Serial No. : 10/762,793
Filed : January 22, 2004

REMARKS

Fig.1 (Prior Art)

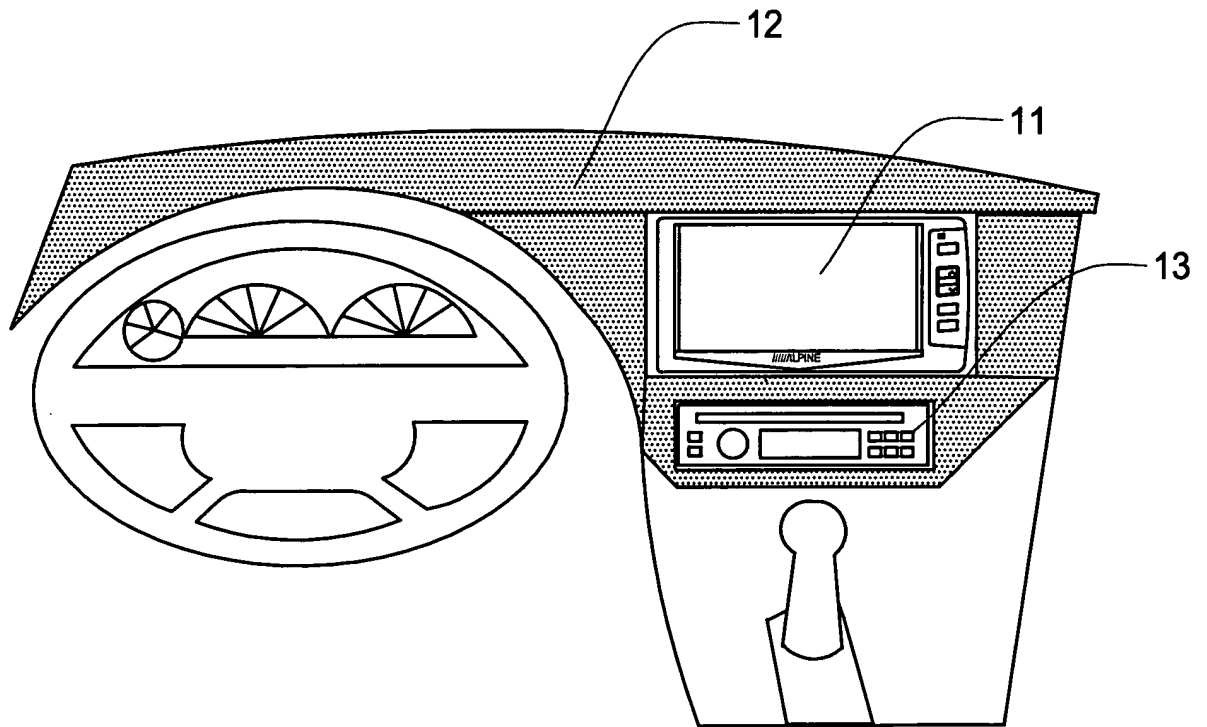
The examiner objected to the drawings on the ground that Figures 1, 3, 4A and 4B lack designations as prior art. Accordingly, the applicant has submitted concurrently herewith a request for approval of drawing changes in which a "Prior Art" label is added to Figures 1, 3, 4A and 4B. The applicant has also submitted replacement sheets for the amended drawings.

The applicant has submitted concurrently herewith a request for approval of drawing changes in which a "Prior Art" label is added to Figures 1, 3 and 4A-4B. The applicant has also submitted replace sheets for the amended drawings.

Fig. 4A (Prior Art)

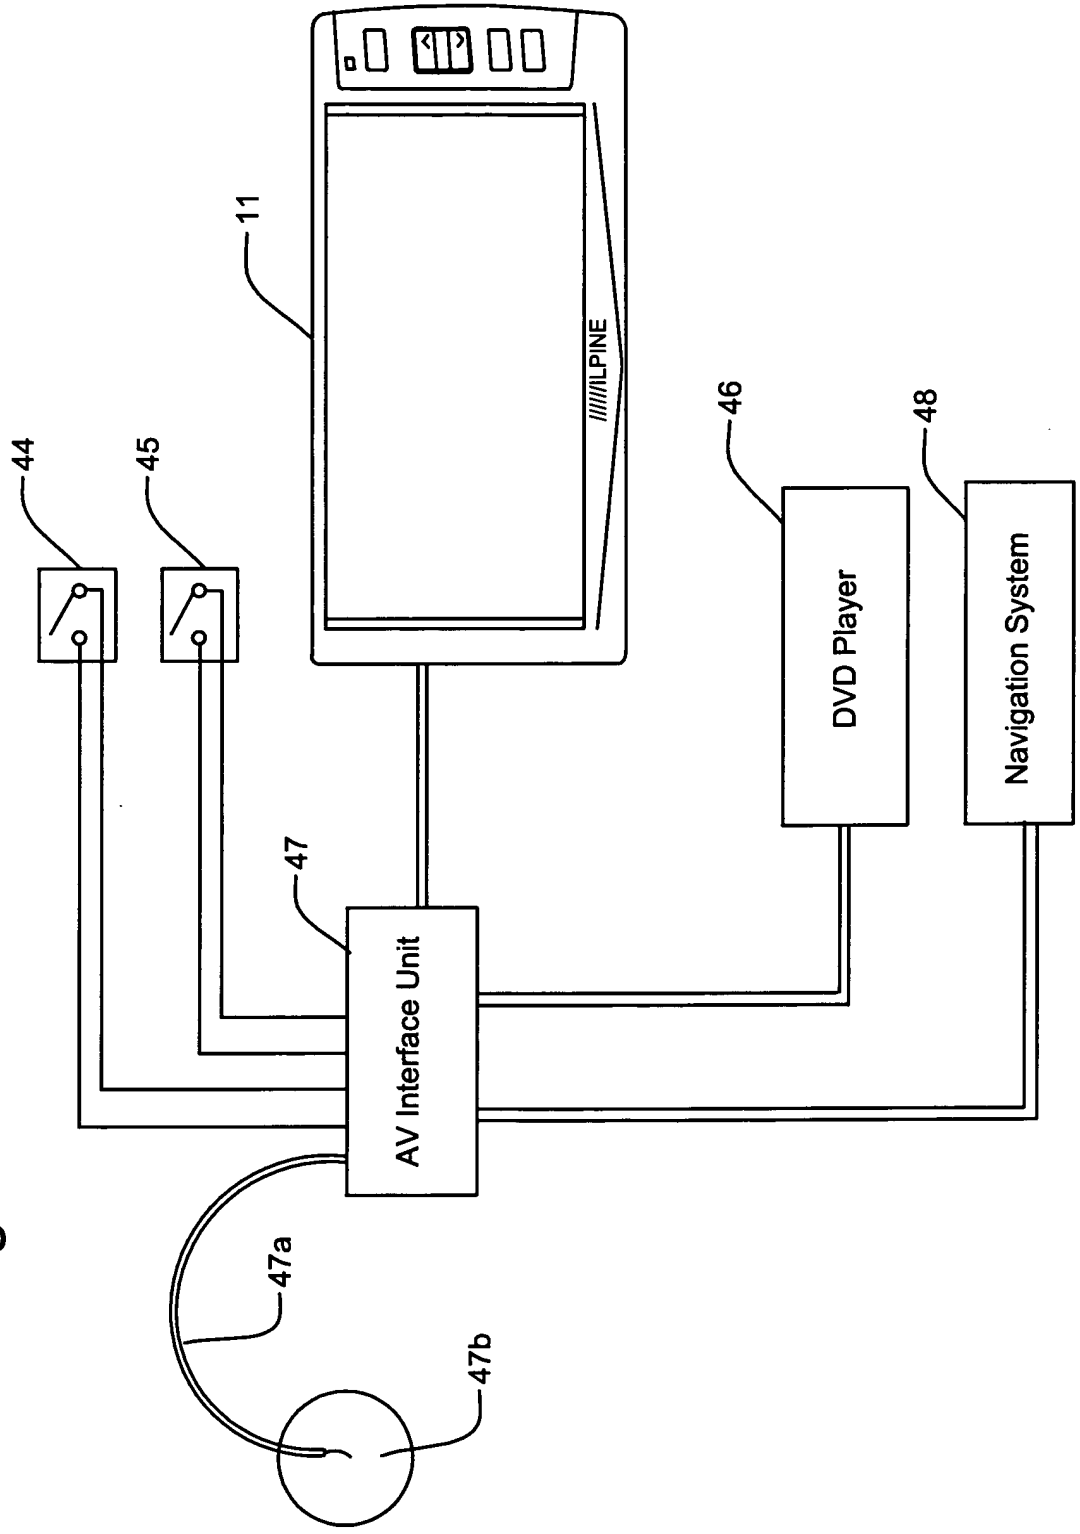
The admitted prior art shown in Figure 4A needs a wire for connecting the AV interface unit 47 to the ground to release the brake interlock function. As known in the art, in the application to a vehicle, the ground is a body frame of the vehicle. Thus, in the admitted prior art, the wire (release device) cannot be established within the display compartment formed on the front or
